## ENVIRONMENTAL REVIEW COMMITTEE REPORT

| <b>Project Name:</b>         | Barbee Mill Community Dock II   |   |     |
| <b>File Number:</b>          | LUA10-006, ECF, SM  |   |     |

# EXHIBIT 3

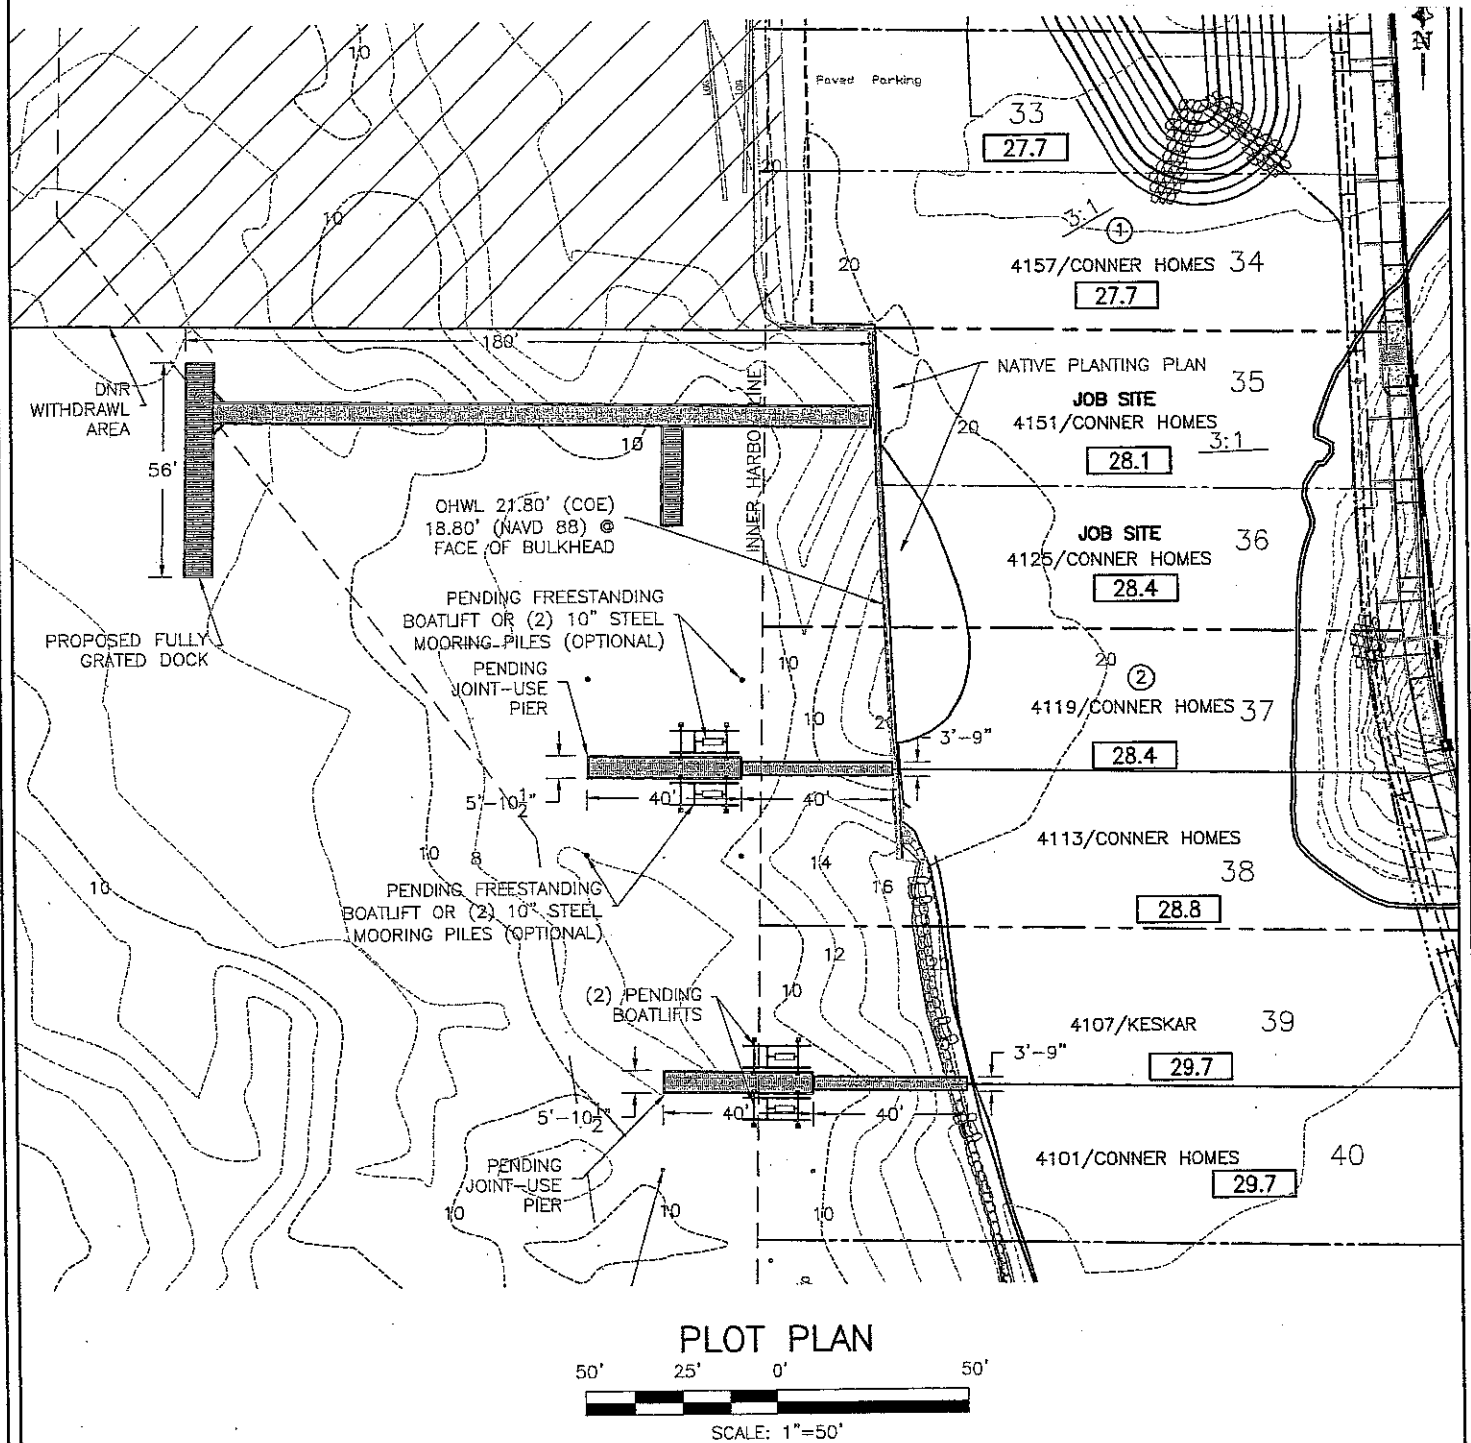
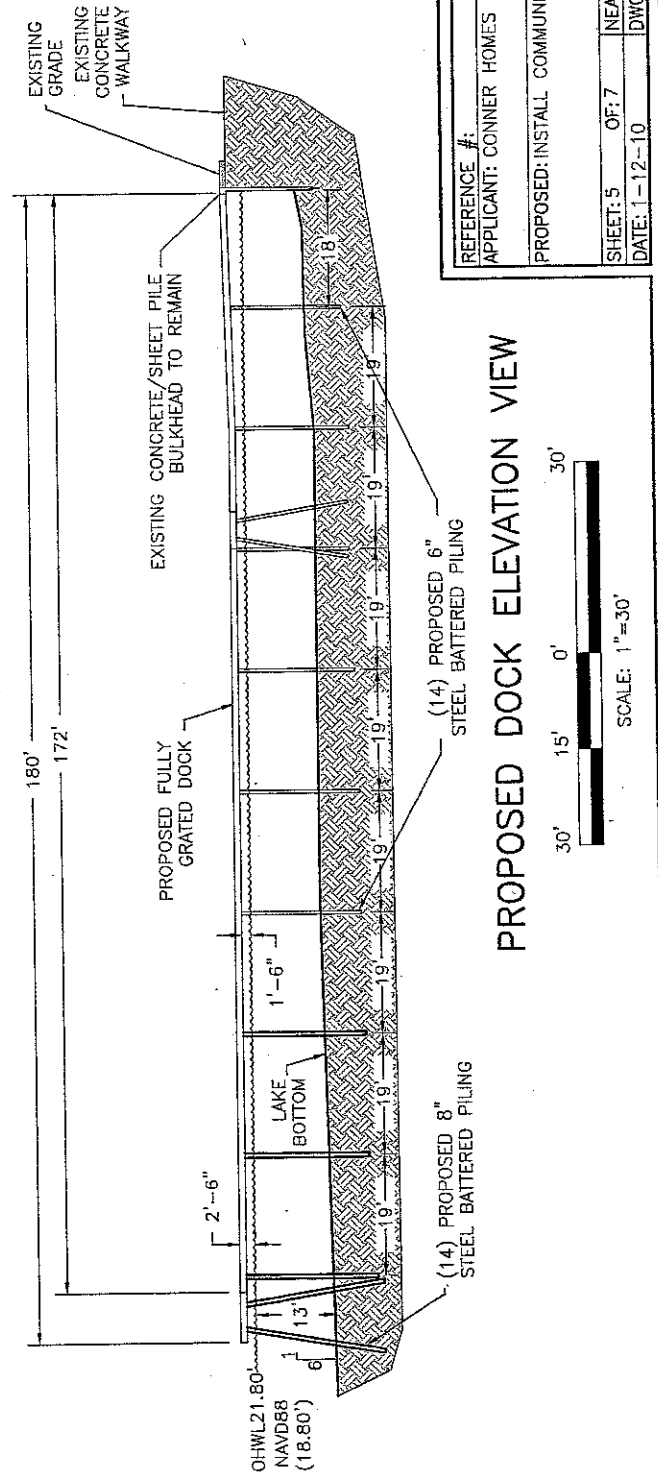
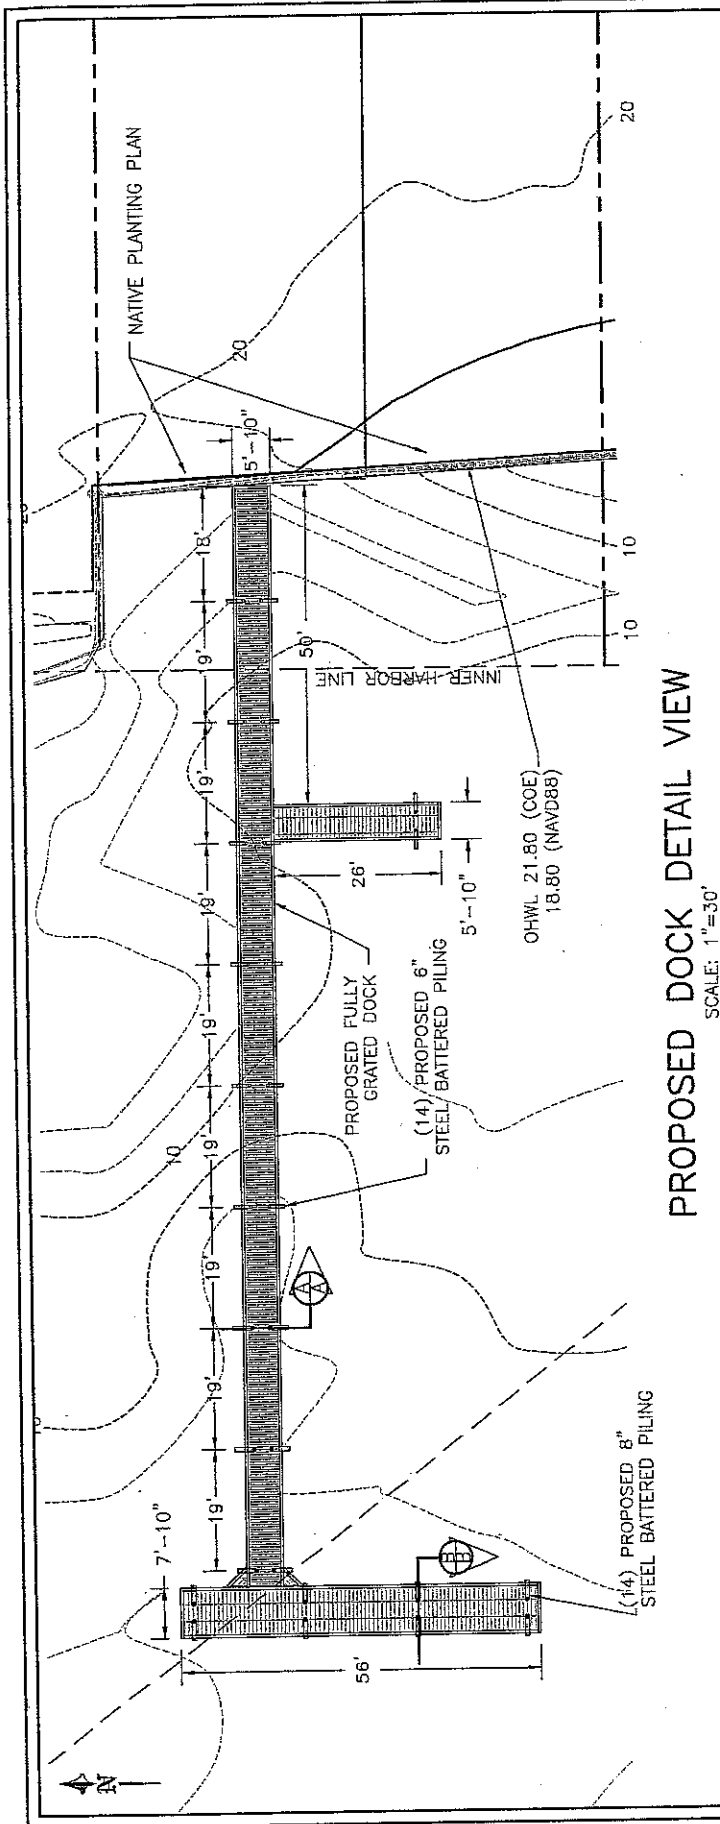
4. The first 30 feet of the community dock should be reduced in width to a maximum of 4 feet. It is currently proposed for 5'10" width.
5. The information regarding the vegetation plan is insufficient. Per the Administrative Site Plan Review Report and Decision (dated March 19 2007) for the Barbee Mill Level 1 Site Plan review, it states:

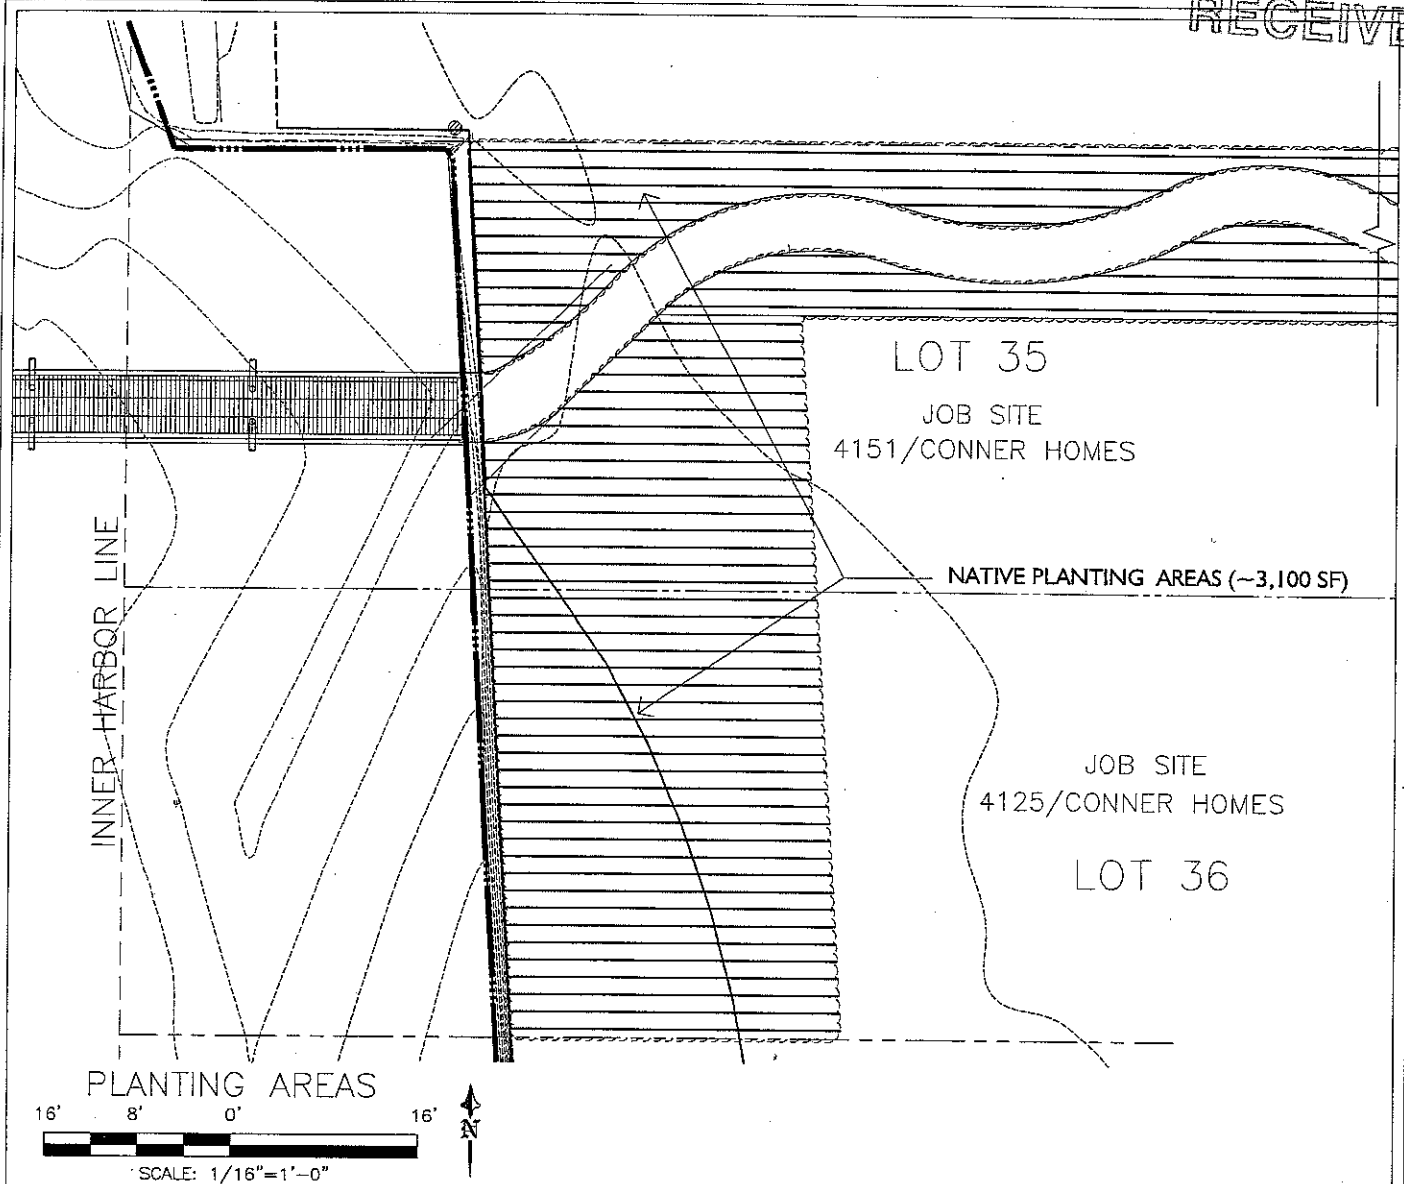
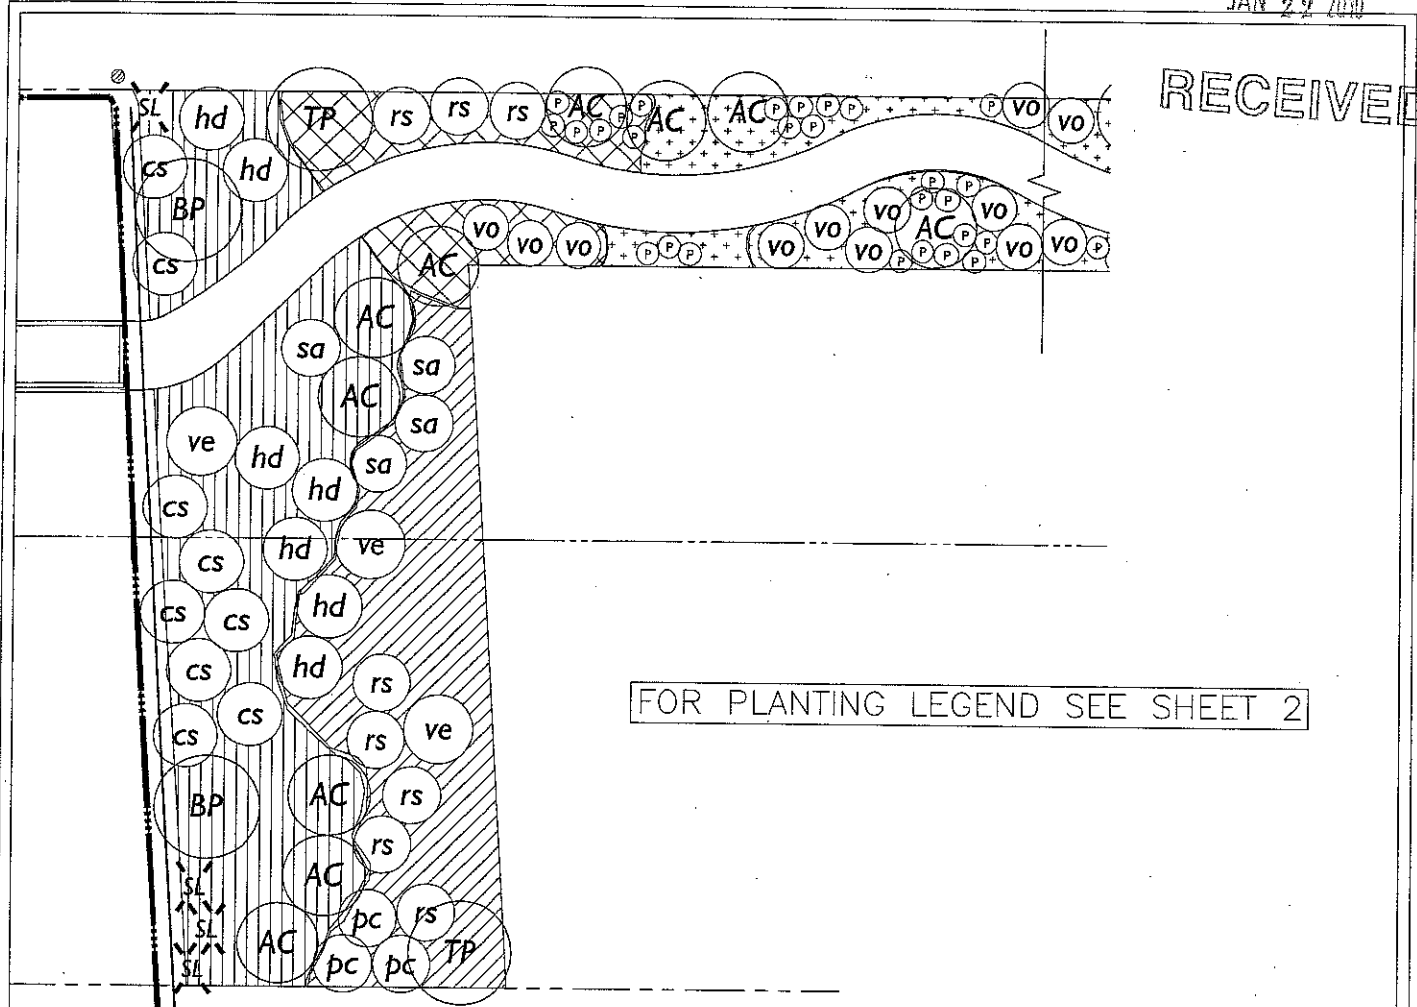
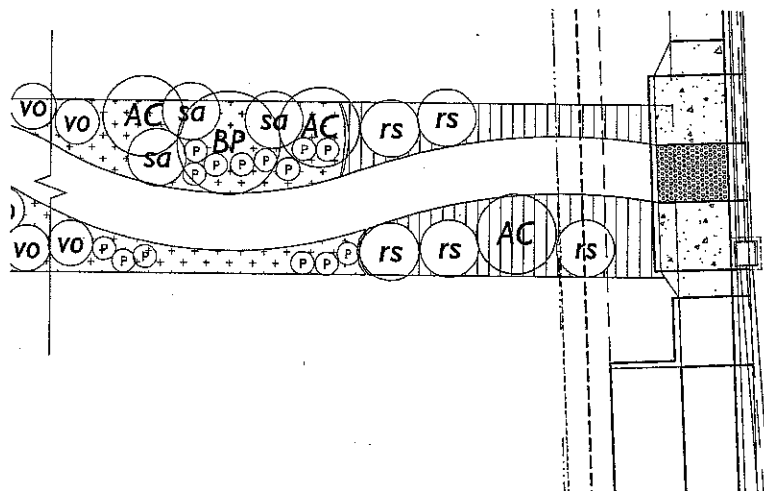
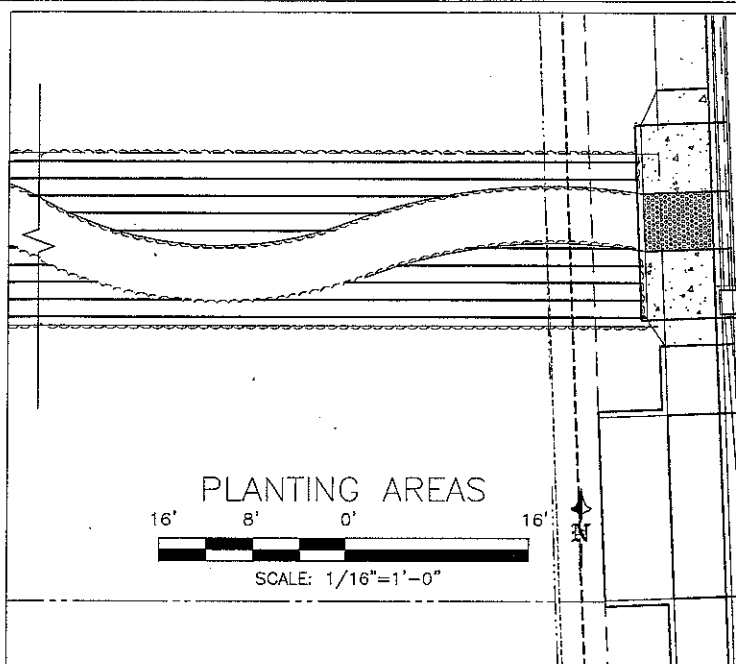
We have reviewed Figures 7-9 and are unable to discern where the additional plantings are compared to the existing plantings that were required from the plat conditions for the 35-foot native plant zone. A new figure needs to be created that shows exactly where, how many, and what plant species were planted in the 35 foot native plant zone that was required from the plat conditions. Another figure should be created that shows the existing plantings and where, how many and what plant species are proposed as additional plants that will serve as mitigation for the community dock. We are concerned that the project is attempting to seek credit for the previous plantings done as required by the plat conditions as mitigation for the new dock.
